MEMORANDUM

Subject: Review of Sourz HVR, Inc. Evaluation of Impacts to Groundwater Resources - Lake County UP

21-10 and IS 21-10

To Appeal (AB 21-04) of Early Activation/Major Use Permit (EA/UP 21-10) and Initial Study (IS 21-10), Dated November 15, 2021

Figure 1. Depth of water (feet bgs) recorded at Well #4 from 1961 to 2020.

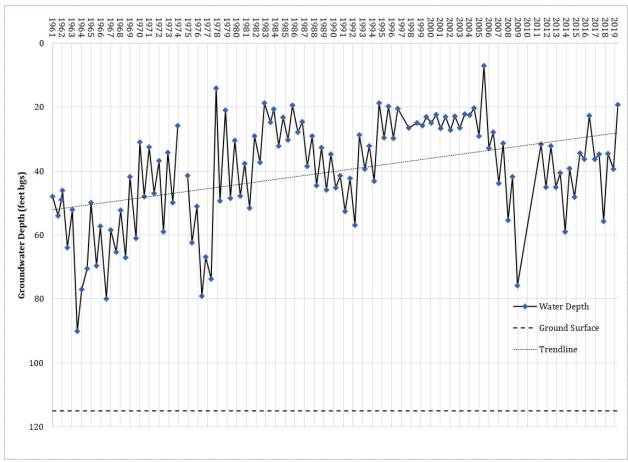
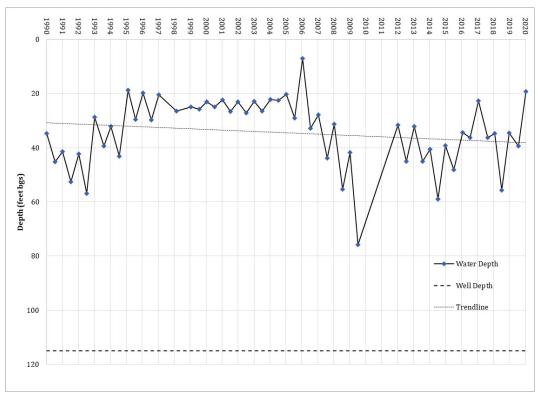
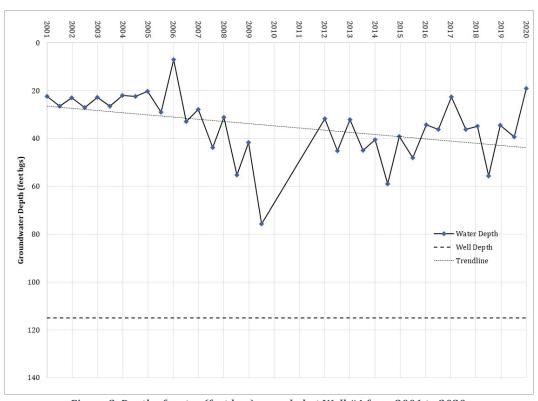
Also not discussed in the IS/MND, TM, or the Revised TM, is that Well #4 is a California Statewide Groundwater Monitoring (CASGEM) Program monitoring well (CASGEM Well ID #35927) that has been used to track and monitor seasonal and long-term groundwater elevation trends in the High Valley Groundwater Basin since 1961. Groundwater elevations in the well have been recorded almost every March and October since 1961. CASGEM identifies the monitoring entity as the Lake County Watershed Protection District. Although the general trend in groundwater depth, in feet bgs, appears to have been increasing since the well was drilled, it has been trending downward over the last 10 to 20 years (Figure 1 through Figure 3). This data, accordingly, contrasts with the data provided in the EBA GAS that seems to suggest the Basin has ample storage and recharge capacity.²

- The additional data provided in the Revised TM, including the EBA GAS, suggests that the High Valley Groundwater Basin may have adequate groundwater resources to support the Project, however, competing data, including the poor functionality of wells on the Project site, CASGEM data, and data from surrounding wells, indicates that the useable groundwater capacity of the Basin is far less than indicated in the EBA GAS, and is decreasing rather than increasing. These factors all constitute substantial evidence indicating that the Project may have a significant impact on groundwater resources.
